**ADDENDUM no. 2 to the
FINAL ENVIRONMENTAL IMPACT REPORT/ENVIRONMENTAL ASSESSMENT for
the
U.S. HIGHWAY 50/EL DORADO HILLS BOULEVARD-LATROBE ROAD
INTERCHANGE PROJECT**

AUGUST 2008

Project Title: U.S. Highway 50/El Dorado Hills Boulevard-Latrobe Road Interchange
EIR/EIS ADDENDUM no.2

FIGURE D

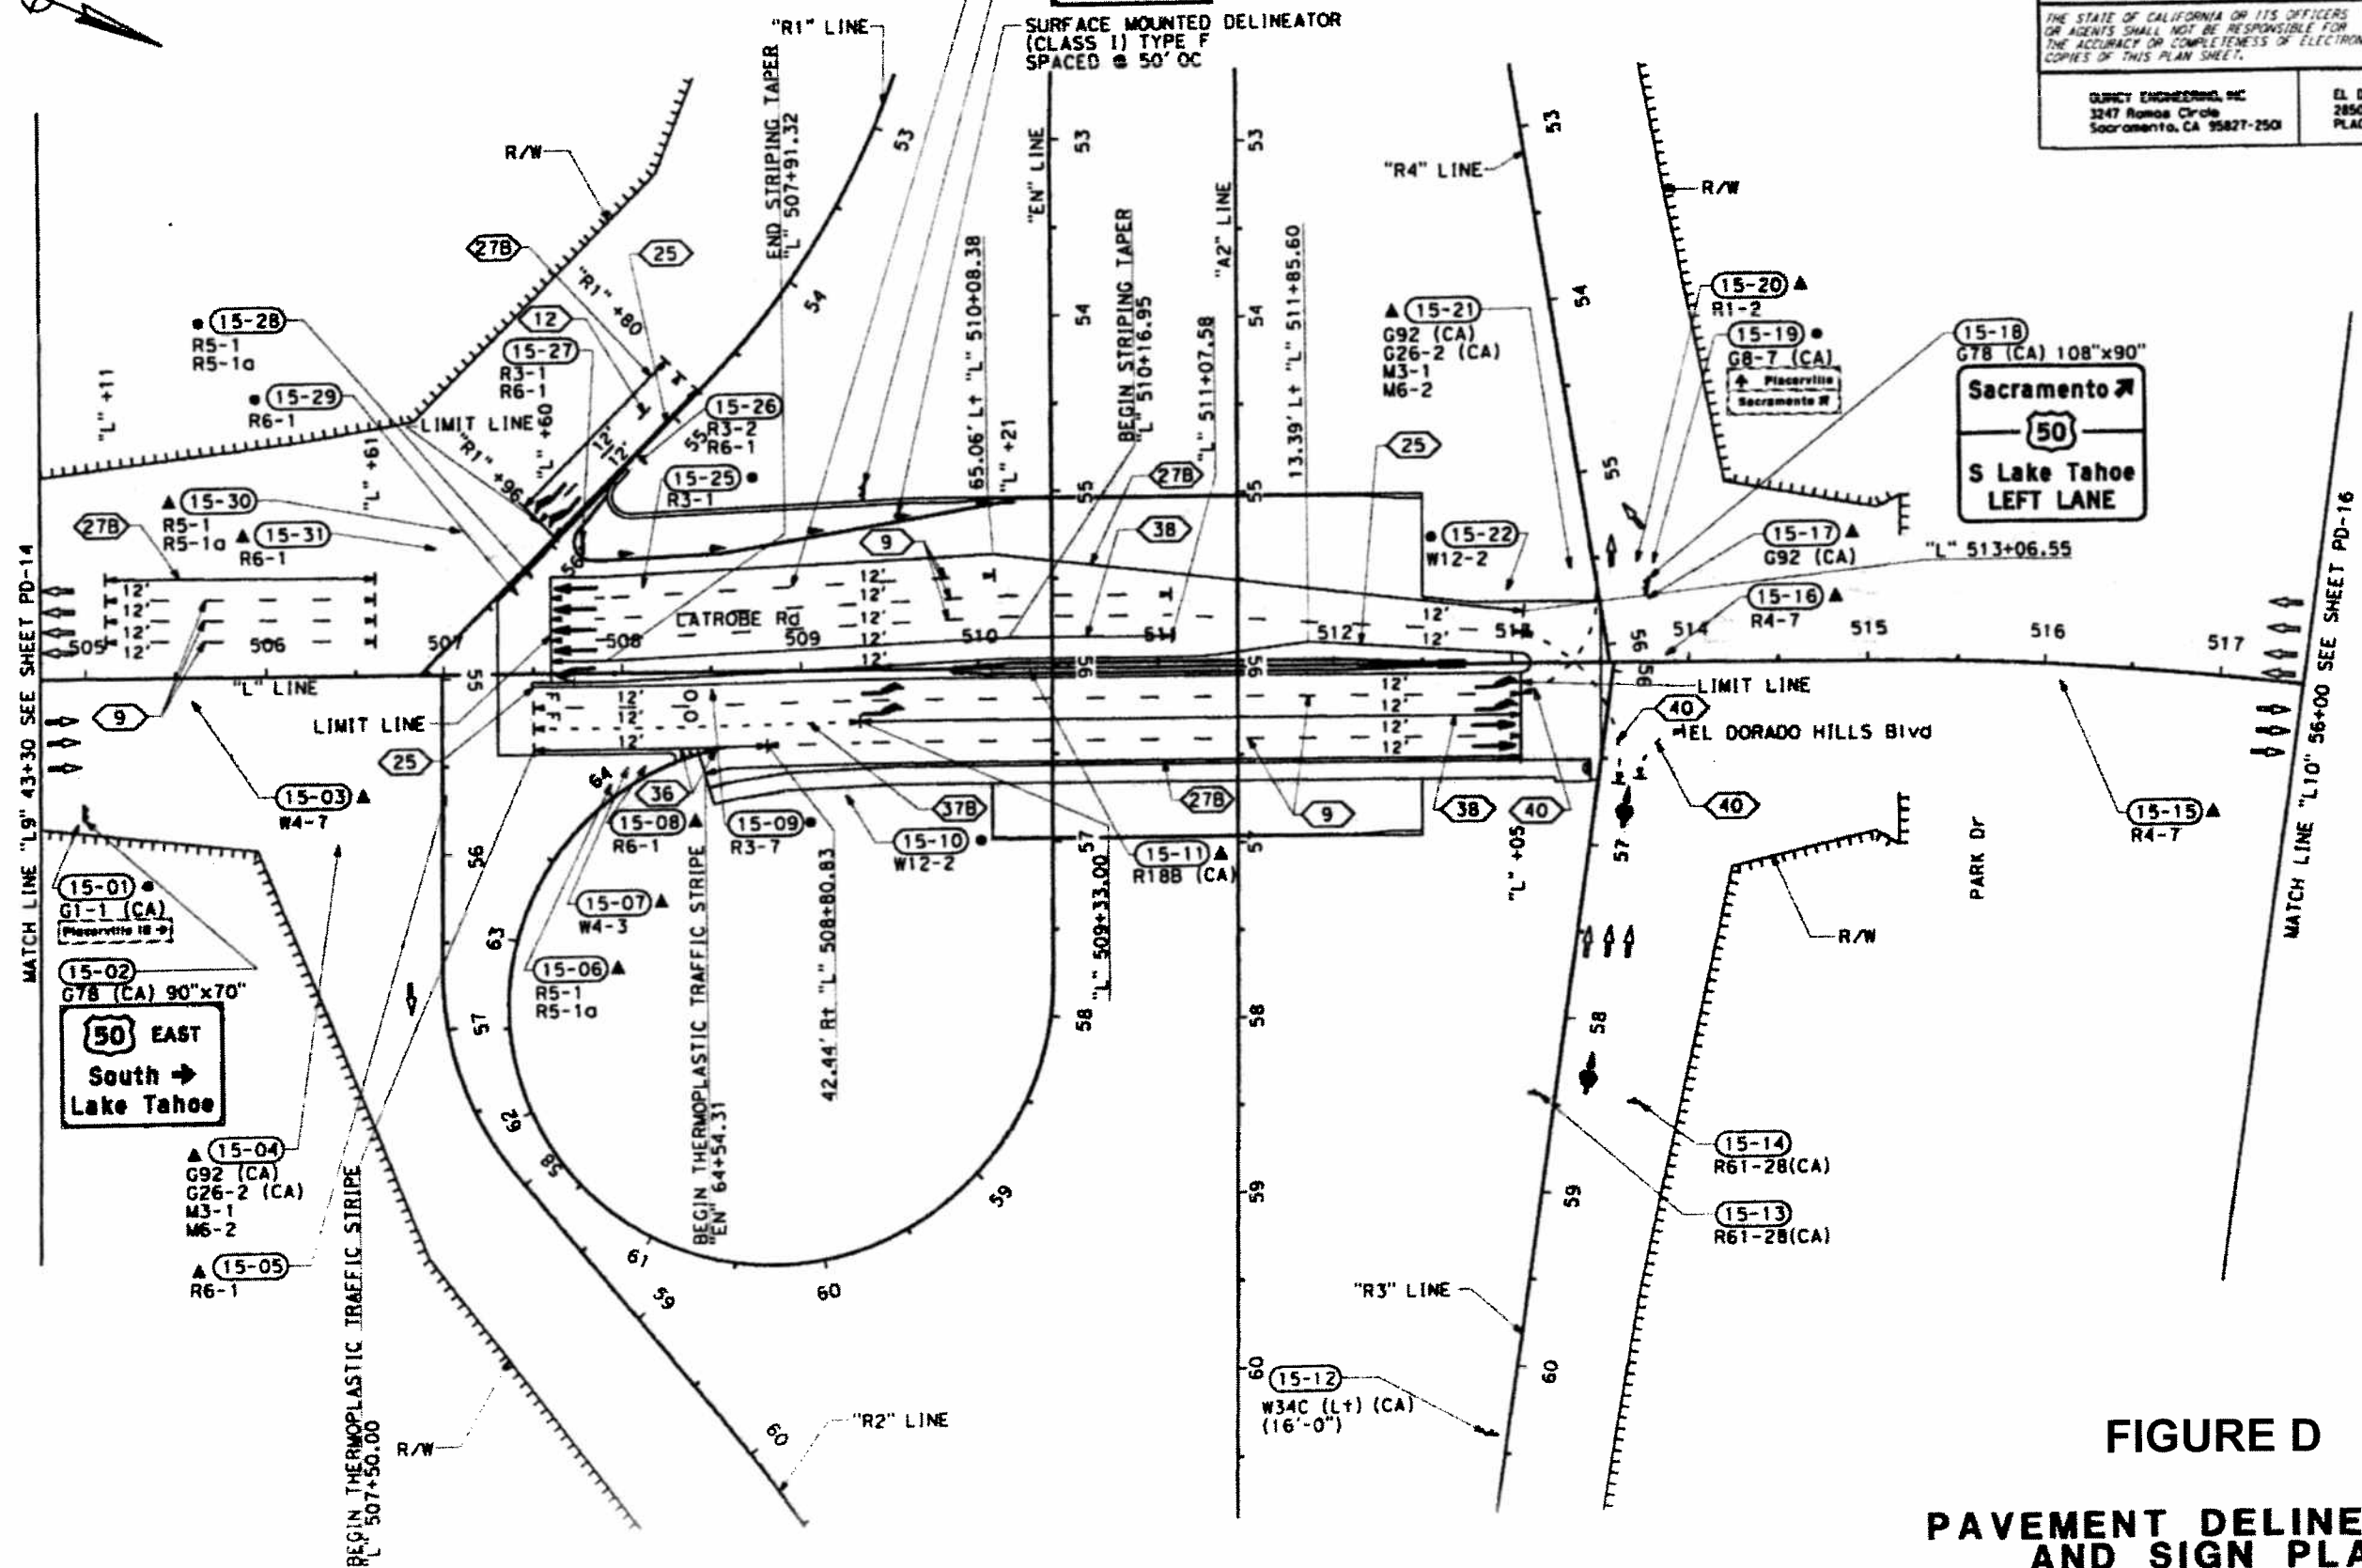
The approved project included the construction of three through lanes and two dedicated left-turn lanes on the northbound and southbound sections of El Dorado Hills Boulevard/Latrobe Rd beneath the bridges and approaching the adjacent intersections with the Hwy 50 ramps as shown in Figure C, which is an enlargement of Figure B. Phase 2A proposes to construct, as an interim condition, the lanes shown in Figure D.

A traffic study by Dowling Associates (November 6, 2007), Figure E, indicates that the length of the turn lanes depicted in the EIR/EA must be increased to operate at level-of-service D or better at the intersections. To prevent traffic from spilling back into the through lanes and blocking through traffic, the needed minimum length of the two northbound lanes is 875 feet long and, ultimately, the two southbound lanes need 550 feet. The current proposed construction phase will extend the two existing northbound and a single southbound turn lanes to provide more storage capacity for turning traffic as shown on Figure D. The second southbound turn lane will be striped in phase 2B after the ramp is widened to receive the second turn lane.

The roadway width on El dorado hills Blvd/Latrobe Rd between the interchange ramps will be increased from approximately 130 feet to a varying width of approximately 130 feet to 190 feet in phase 2A to accommodate the lengthened turned lanes and to accommodate the remaining through and turning traffic lanes constructed in phase 2B. In addition, the lane striping at the southbound approach to the El Dorado Hills Boulevard/Latrobe Rd intersection with the Hwy 50 eastbound ramps will be modified to 4 through lanes and one dedicated left-turn lane (see Figure D) in this interim phase 2A. These 4 through lanes will provide operational improvements at the ramp intersections by providing more through lanes thus reducing the congestion caused by cars spilling back from the single left turn lane and blocking through traffic. The current project would provide paved surface for 5 lanes and permit the ultimate phase configuration of 3 through and 2 left turn lanes after modifications to the eastbound on-ramp in phase 2B to receive 2 lanes.

FIGURE F

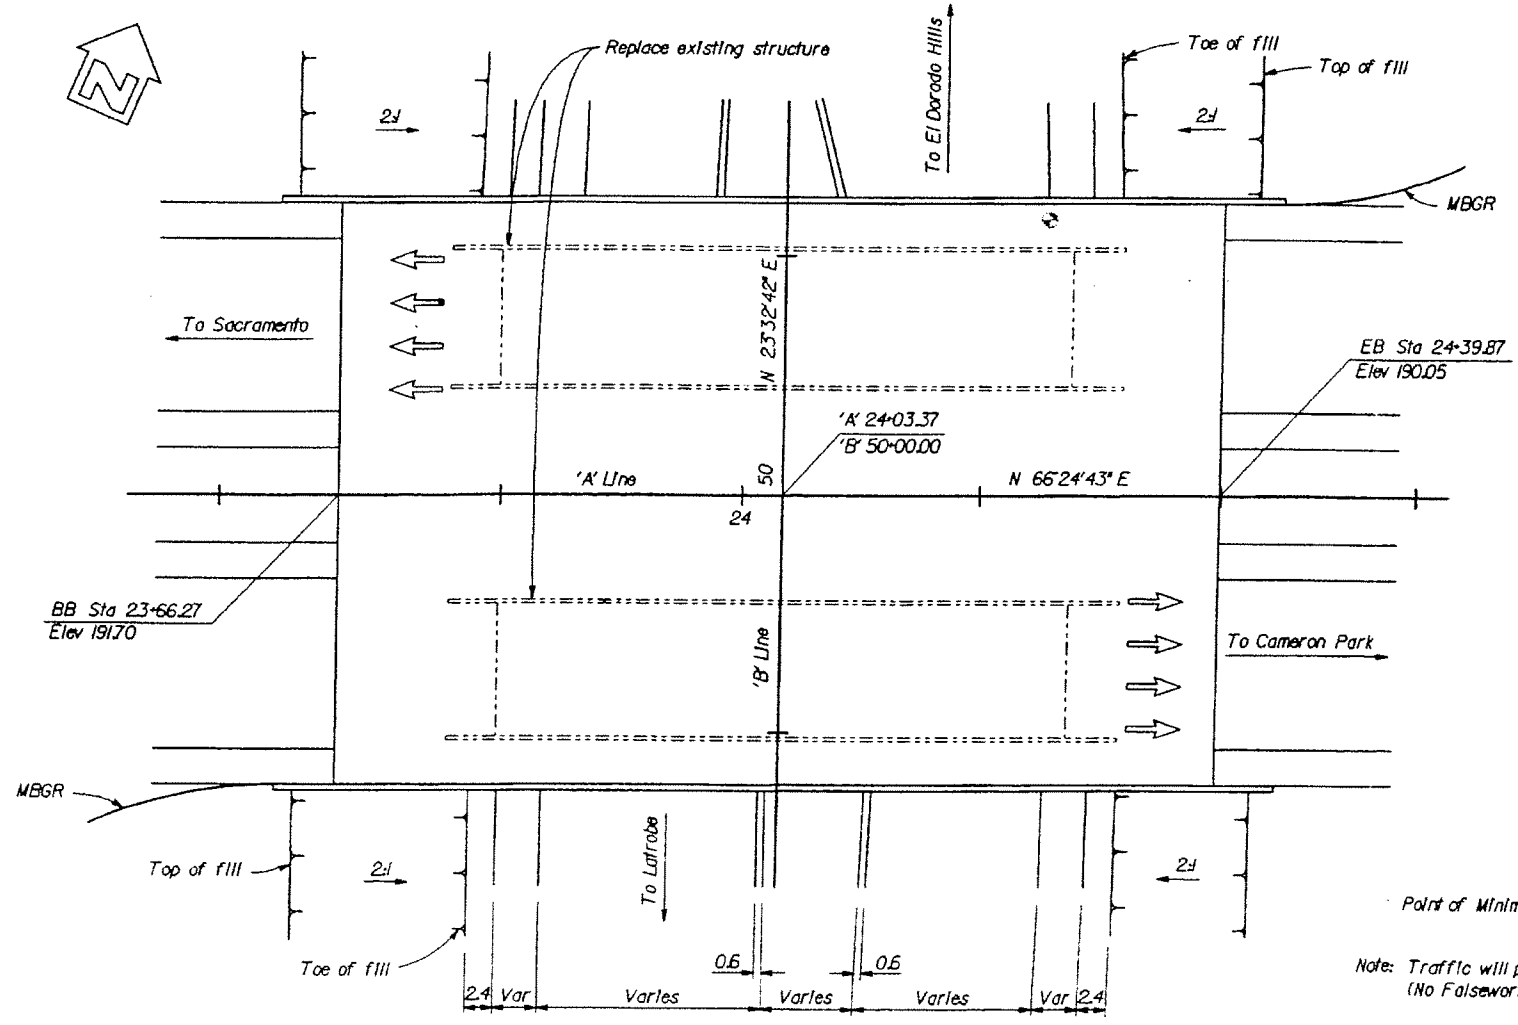
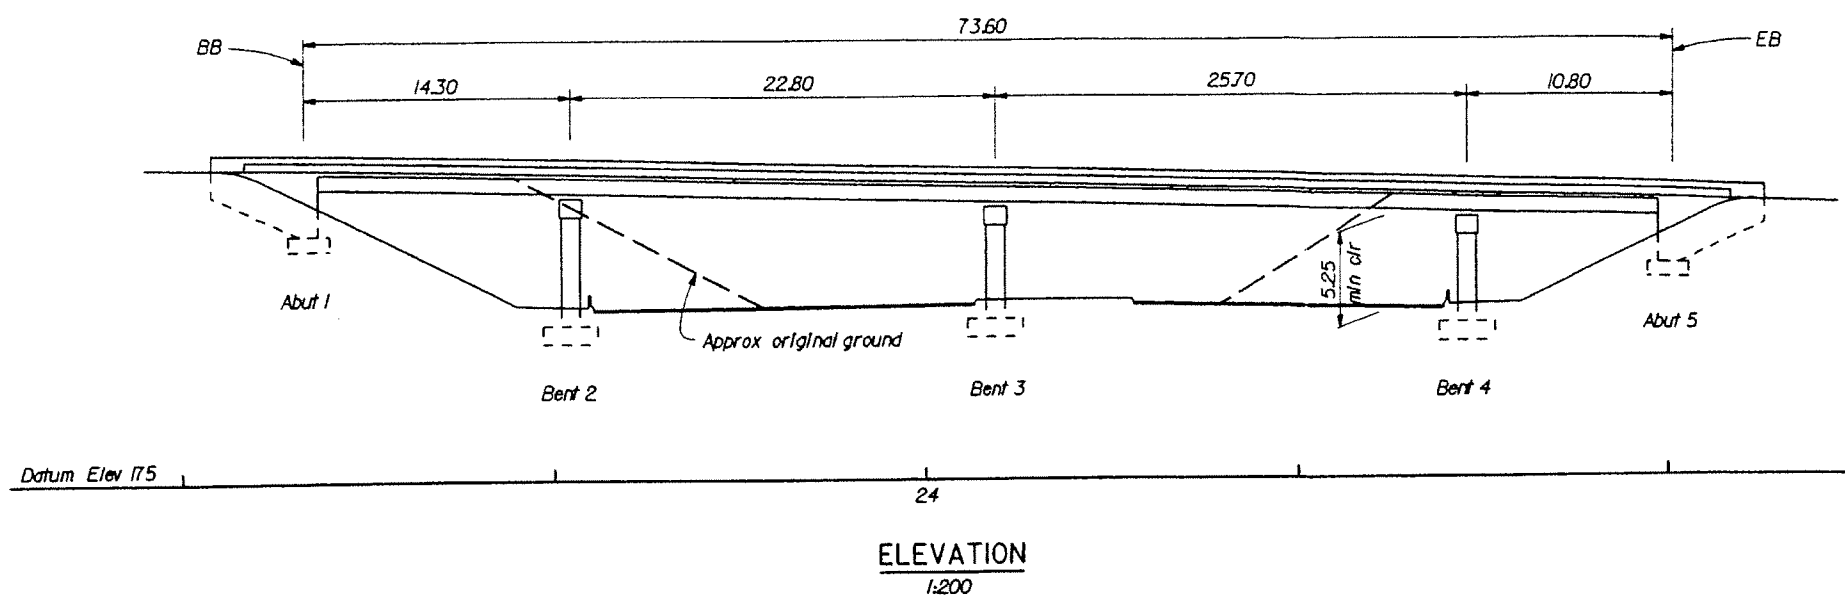
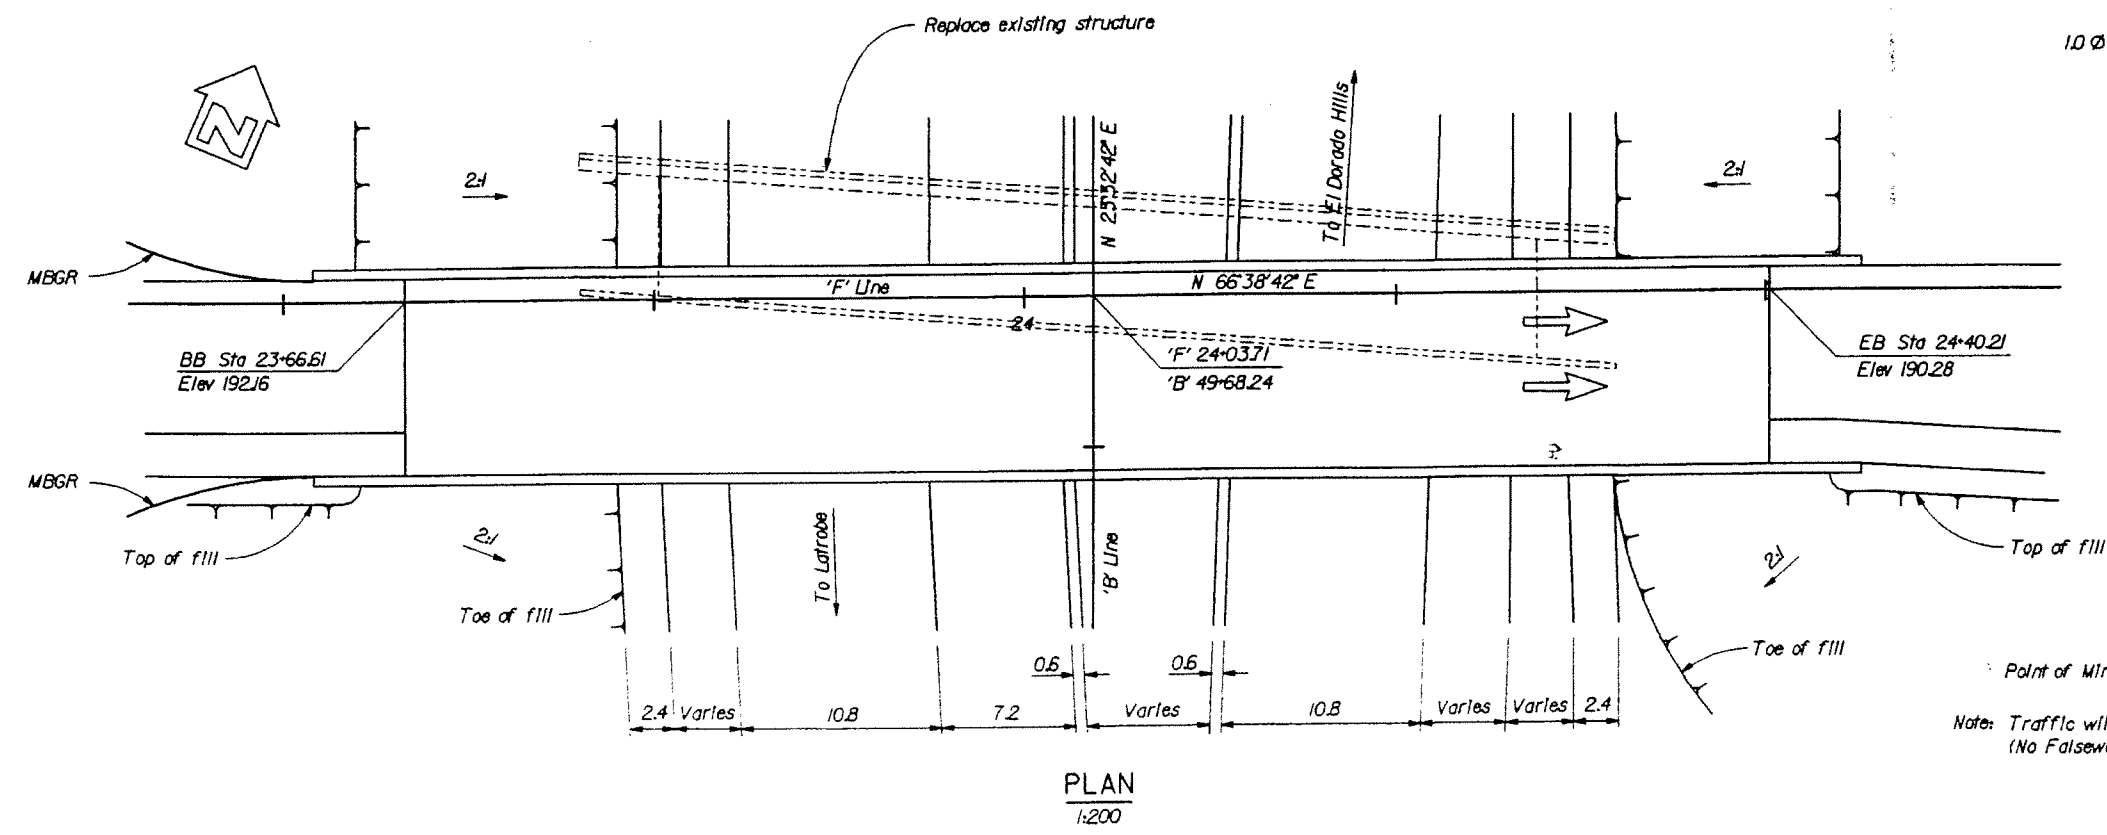
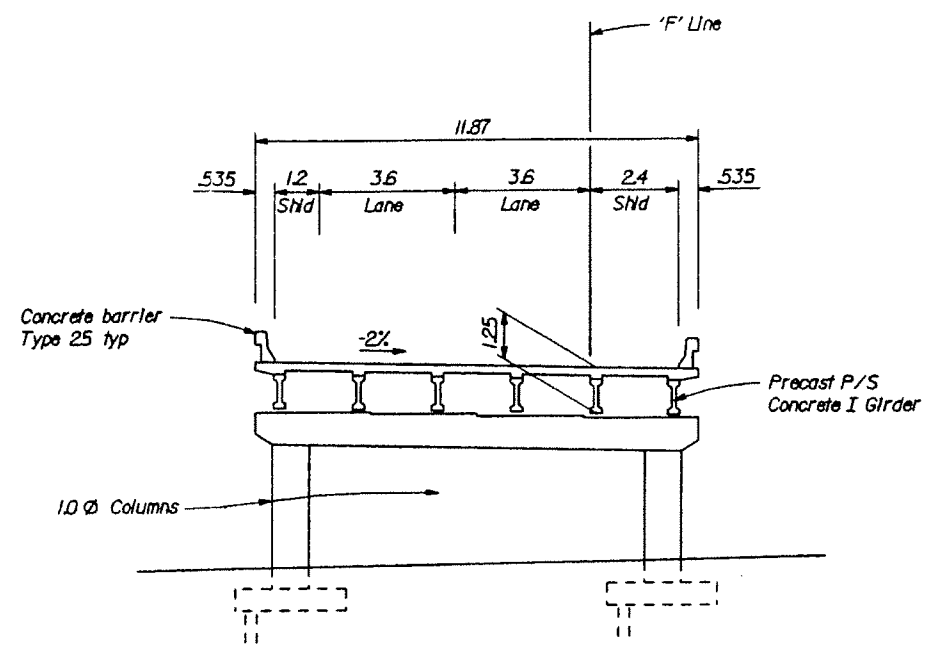
The approved project included the replacement of bridges for the US 50 mainline traffic and the eastbound off-ramp traffic. Detailed discussion and detailed drawings of the bridges were not included in the EIR/EA but general depictions of the bridges were included within the exhibits. However, the County is aware of the bridge type and dimensions of the bridges depicted in the EIR from the preliminary design work done at that time. The original mainline bridge is depicted in Figure F and the EB off-ramp bridge is depicted in figure G.

The original type of bridge structure (4 span, cast in place concrete box girders with open end abutment) could not be economically built due to the requirement to maintain a minimum vertical falsework clearance for traffic under the bridge during construction. The proposed replacement bridges are 2 span precast concrete box girders with closed end abutments. The proposed mainline bridge is depicted in Figure H and the EB off-ramp bridge is depicted in Figure I. The bridge length is shorter partially due to hauling limitation for the precast girders. It is also shorter and narrower than the bridge proposed in the EIR/EA because the larger size is not needed and it reduces costs.

The original design dimensions of the mainline bridge in the June 2000 Project Study Report/Project Report (PSR/PR) were 241.5 feet long and 163.67 feet wide. The current proposal would replace the existing mainline bridge with a structure that is 200 feet long and 141 feet wide. The proposed EB off-ramp replacement bridge is shorter for the same reasons but the width (39 feet) remains the same as the bridge in the PSR/PR. The proposed EB off-ramp bridge is 200 feet long vs. 241.5 feet long in the PSR/PR. All replacement bridges are within the same footprint area.
